**WOODBERRY DOWN**

**PHASE 4: WDCO PRESENTATION - 2ND ESCAPE STAIRS  
JULY 2023**

# PHASE 4 UPDATE

This document sets out the proposed amendments to the scheme to incorporate the requirements of the new document.

# PROPOSED SCHEME - BLOCK A2 - TYPICAL FLOOR

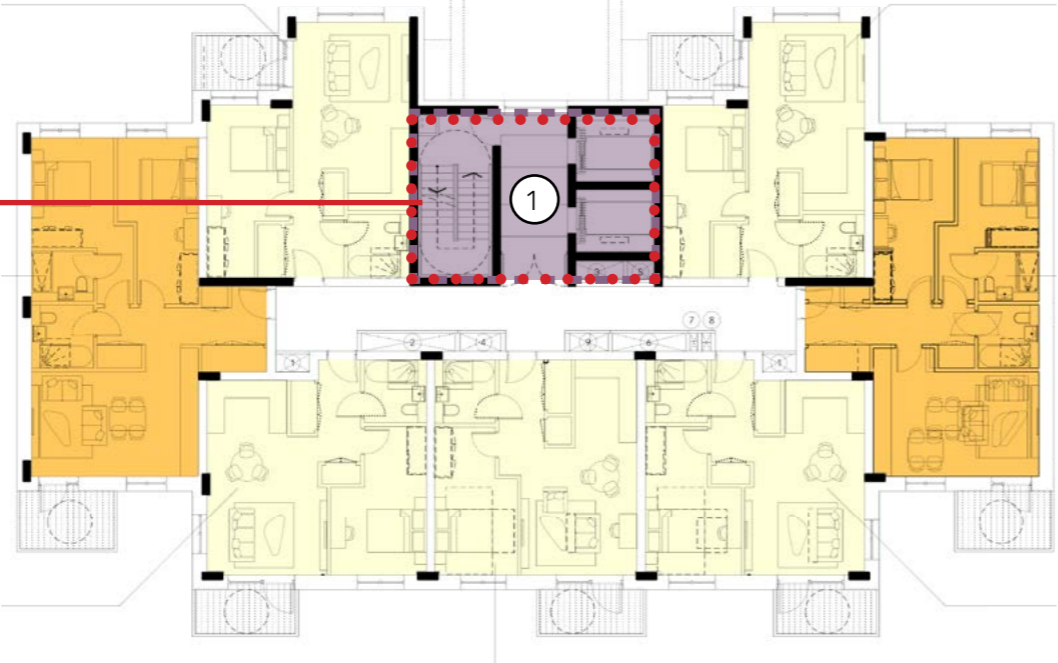
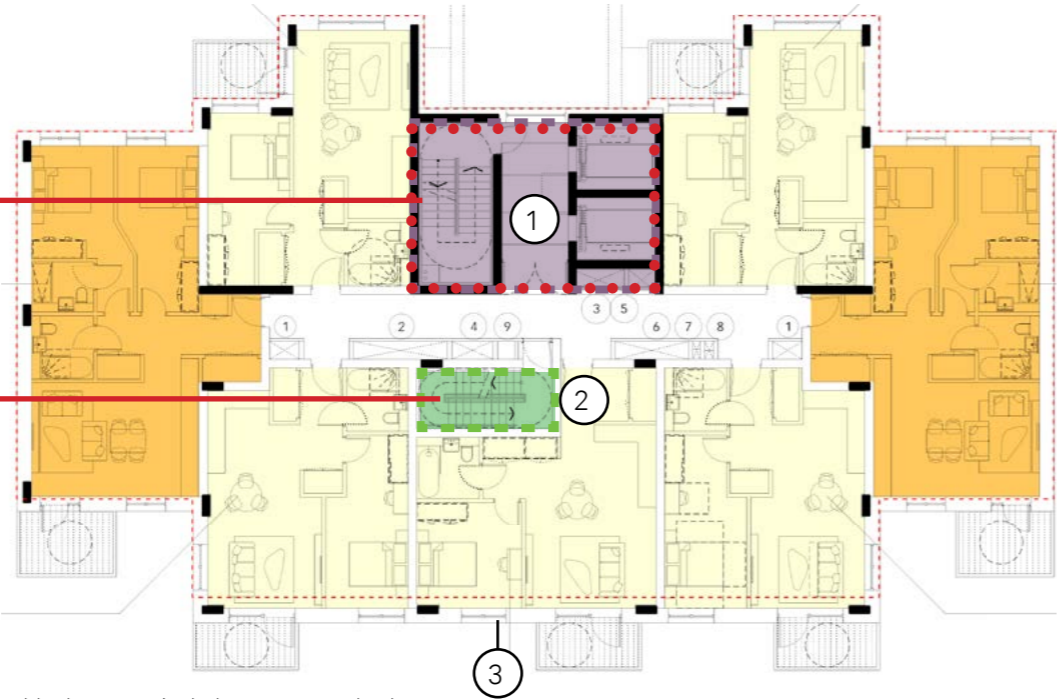
1. Fire fighting shaft with fire fighting lift, evacuation lift and fighting stair.
  2. Separated evacuation stair.
  3. Building is extended towards the courtyard to accommodate the additional staircase
- Keeping the main lift and stair arrangement the same keeps natural daylight to the corridors and entrance at ground floor
  - The apartment layout has changed only in the middle unit to include the stairs. The rest of the apartment remains with the same layout as the 2022 scheme.

# PROPOSED SCHEME - BLOCK B1 - TYPICAL FLOOR

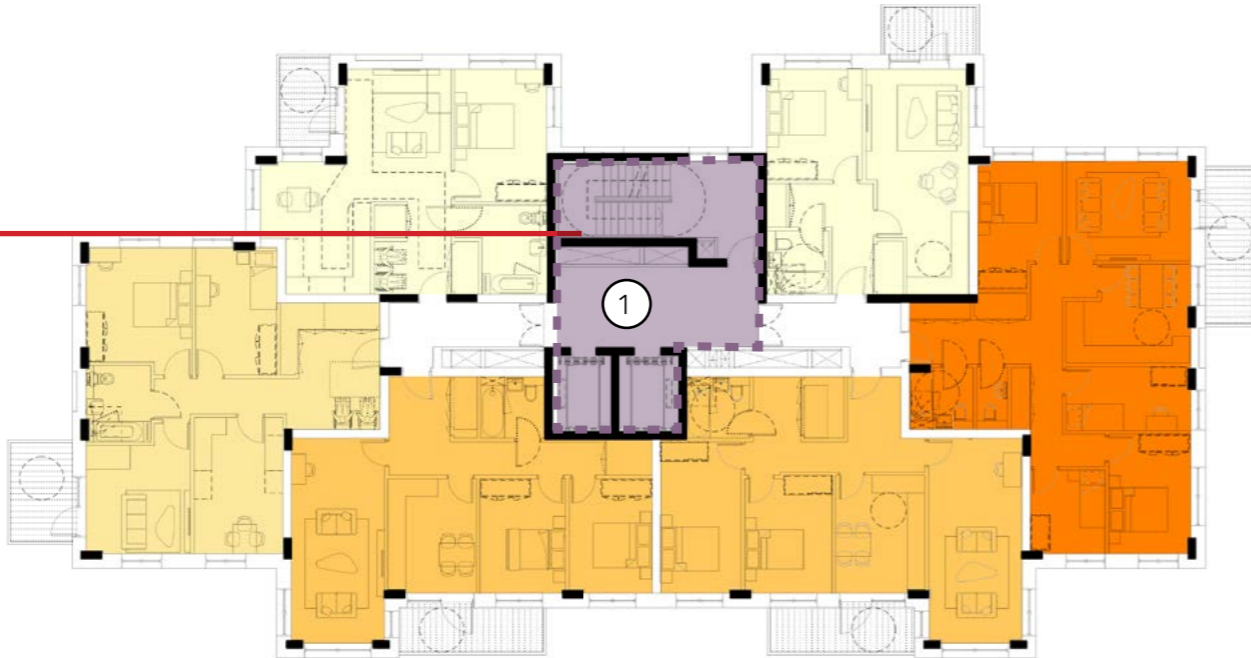
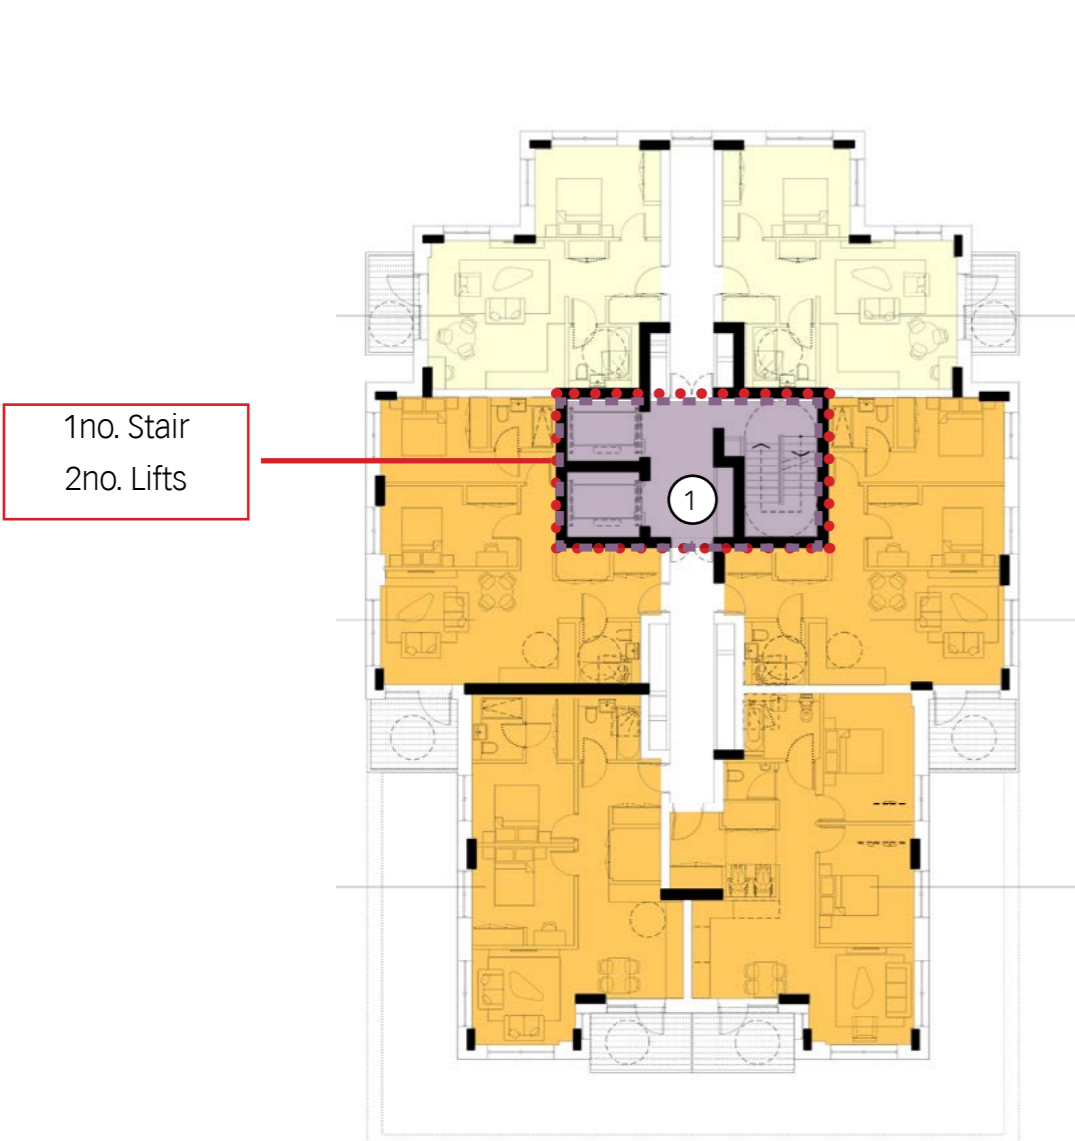
- 1. Fire fighting shaft with fire fighting lift, evacuation lift and fighting stair.
- 2. Separated evacuation stair.
- 3. lift core extended towards to podium garden to make space for the second escape stair.
- The new layout will provide a window straight into the lift lobby - this wasn't possible with the previous design.

# PROPOSED SCHEME - BLOCK C - TYPICAL FLOOR

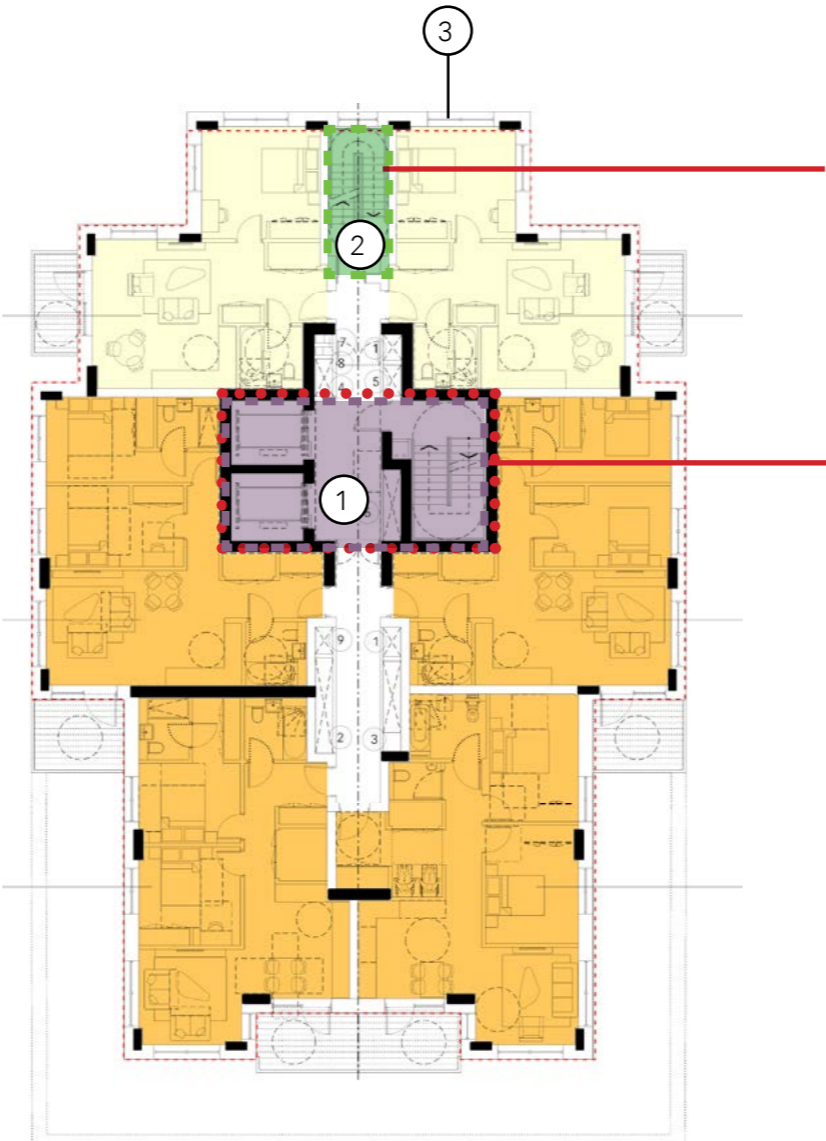
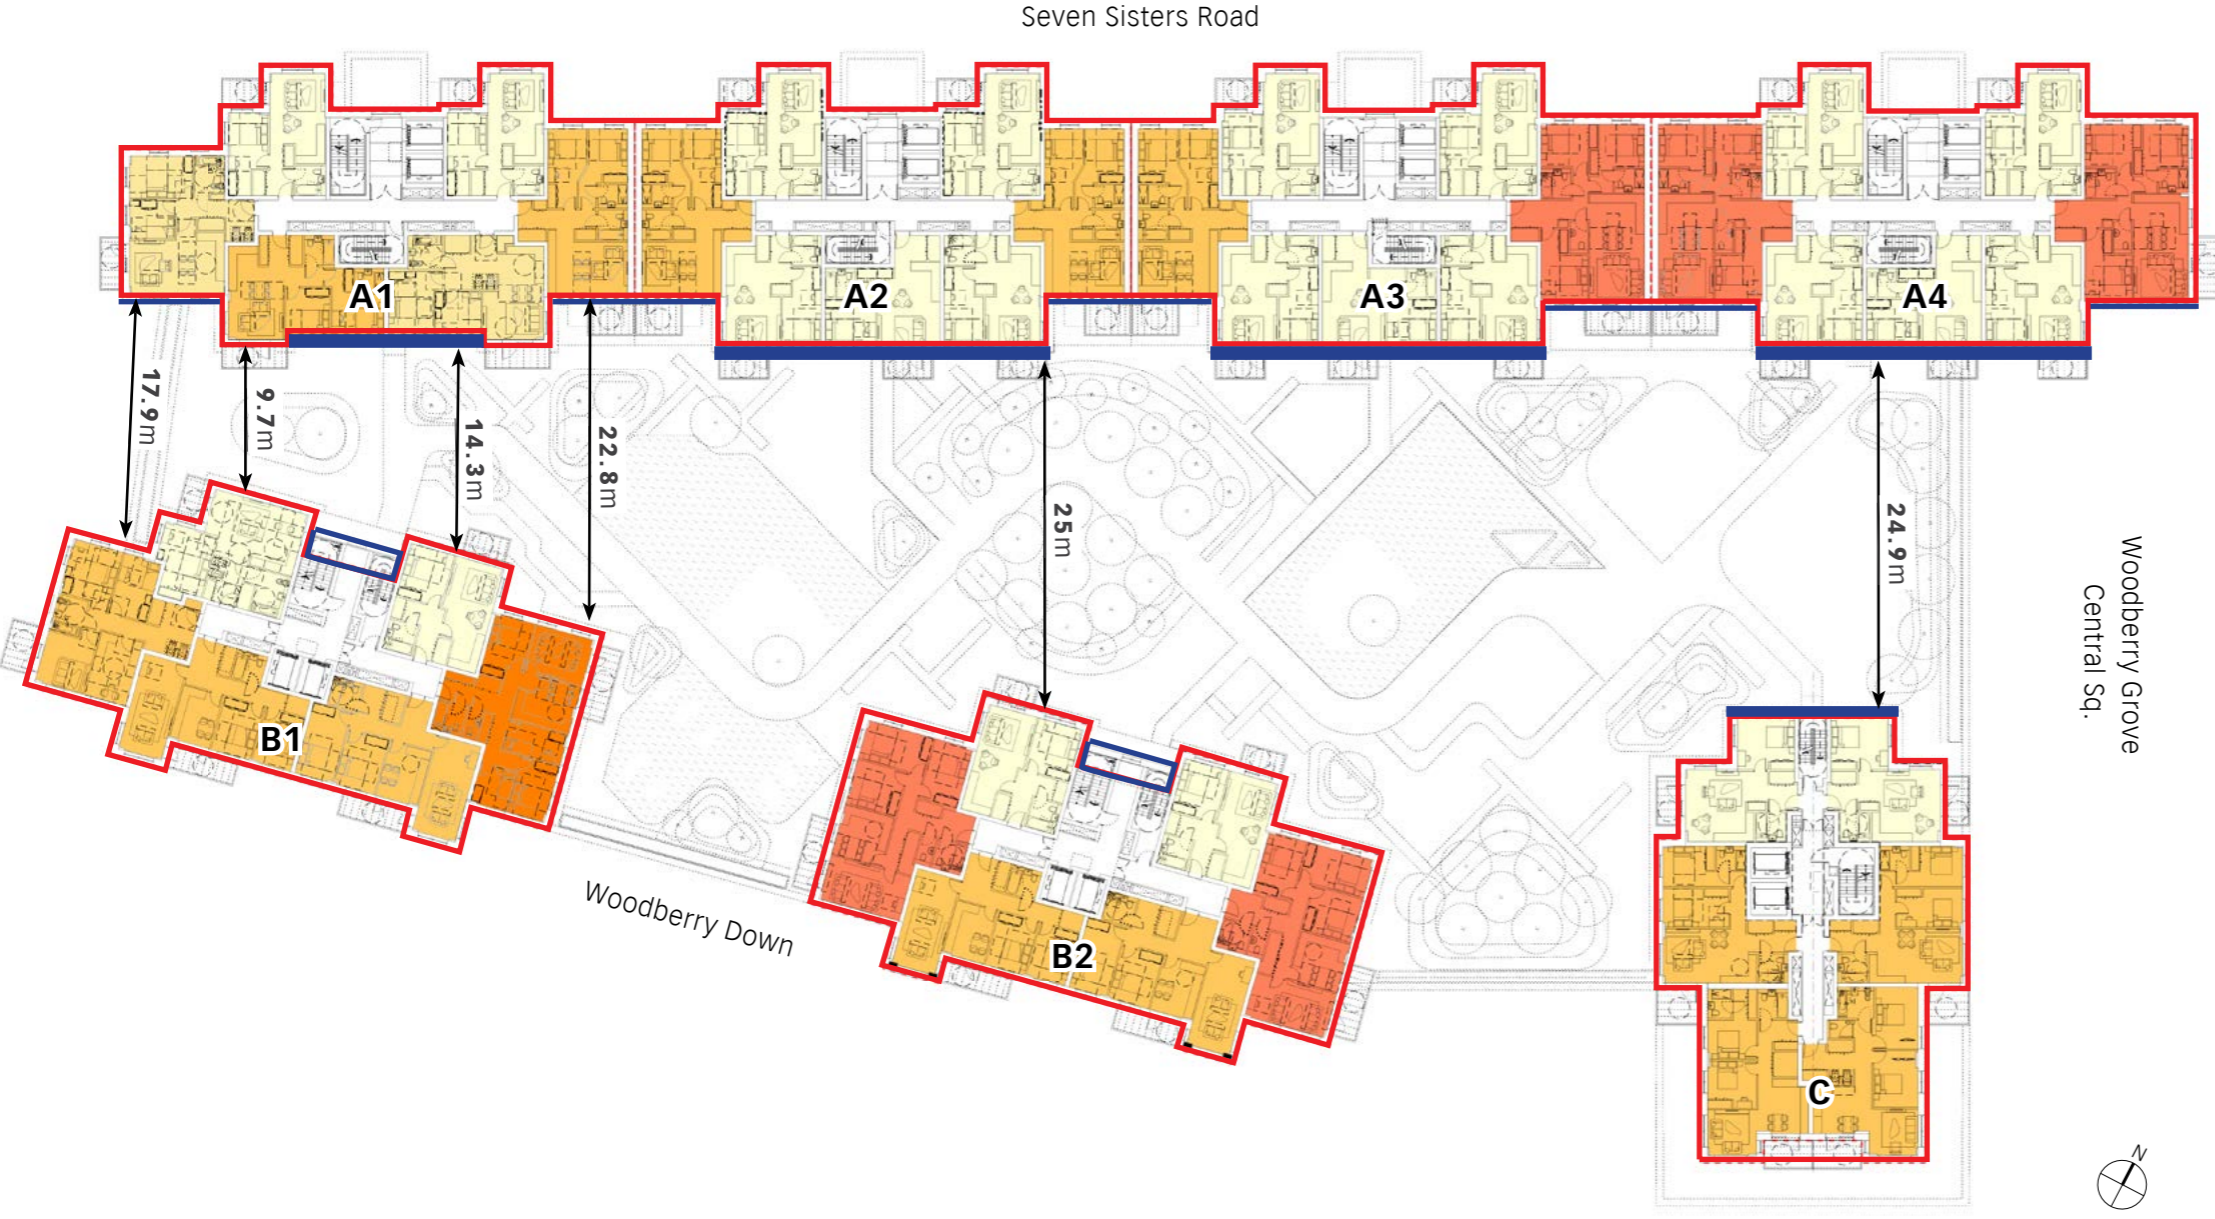
- 1. Fire fighting shaft with combined fire fighting & evacuation lift.
- 2. Separated evacuation stair.
- 3. Extension of the building envelope on the north to accommodated the additional stair.
- glazed doors would be used to allow light and views from the corridor into the building

# PROPOSED SCHEME - GROUND FLOOR PLAN

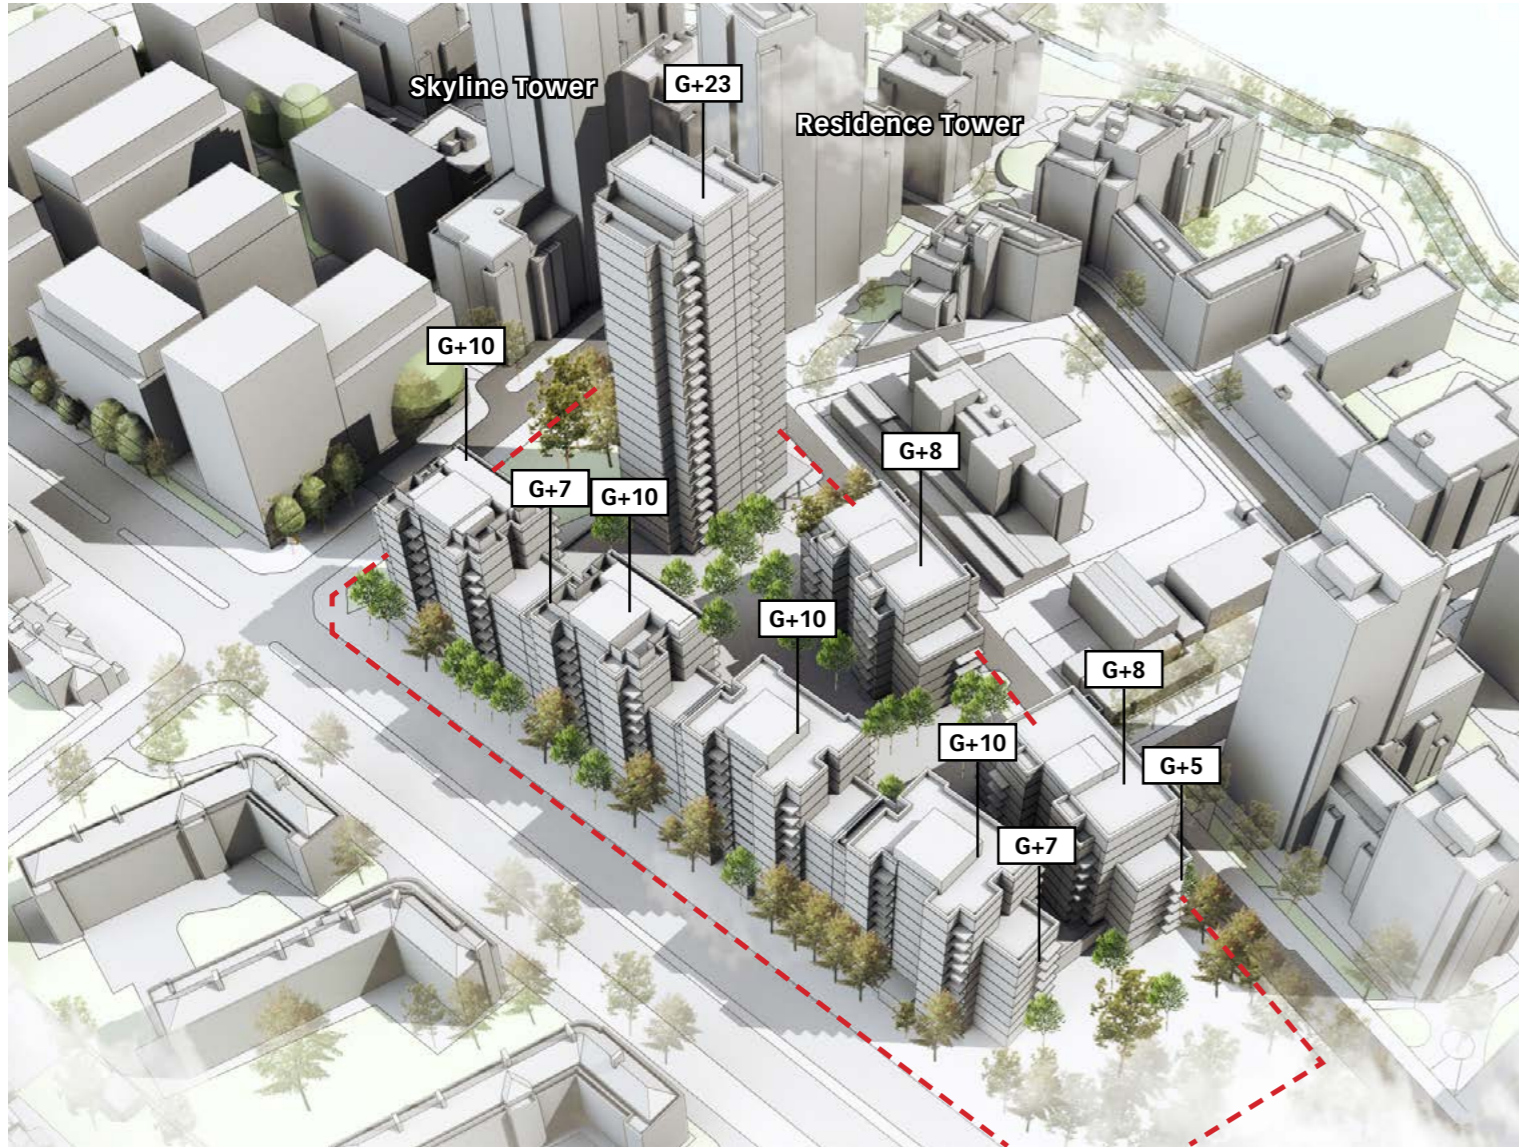
- The revised ground floor has the following changes:
- Each escape stair must individually lead to a final exit on the edge of the building - this requires additional corridors
- As the ground floor is the same size, the corridor space needs to be provided from one of the existing areas
- Residential, service and retail/ community spaces are all critical - therefore its is proposed to reduce the parking space
- The total number of parking spaces is reduced from 65 to 48. Accessible parking percentages are maintained.
- There are enough spaces for all secure tenants in Phase 6 with cars to move to Phase 4. The lost spaces would have facilitated the early decant for people with cars in Phase 7.
- The layout was reviewed and approved by the HSE

02 aerial view - north-west - proposed scheme

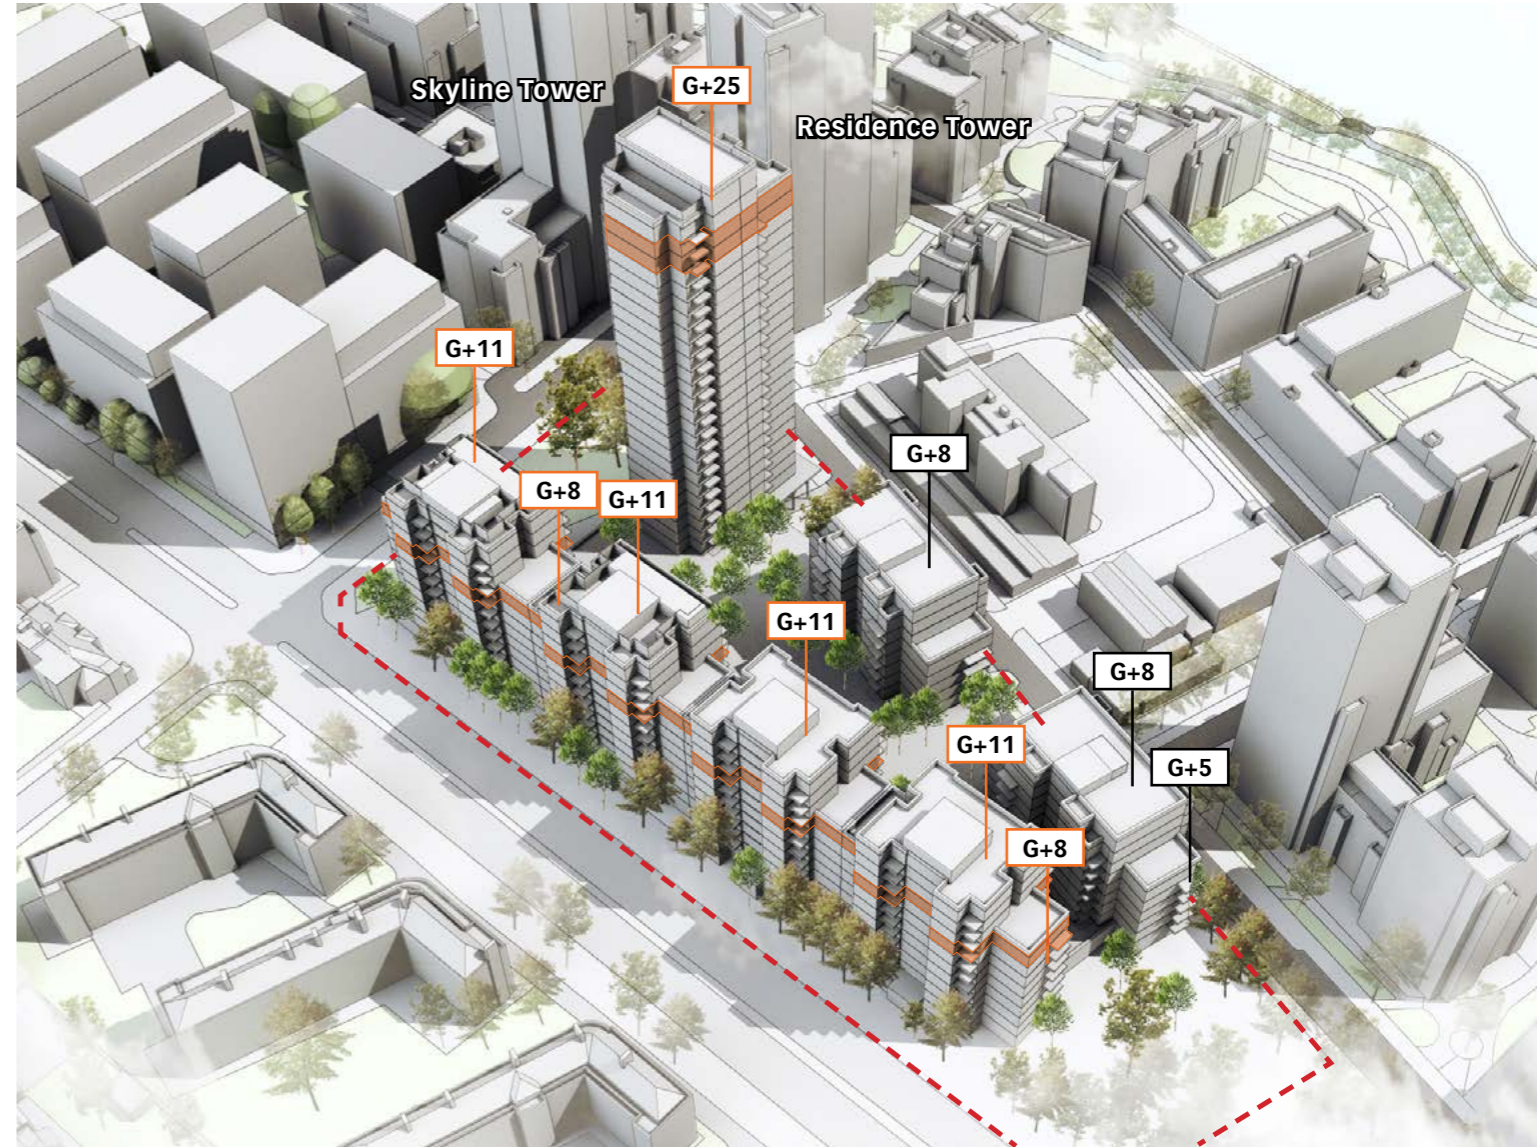
Due to additional costs resulting from the extra staircases and associated changes, additional height is proposed on the scheme to recoup the viability.

The changes to the building heights are led through townscape & environment considerations. This does mean that no additional height is proposed for the 'B' blocks as they sit on the south of the podium.
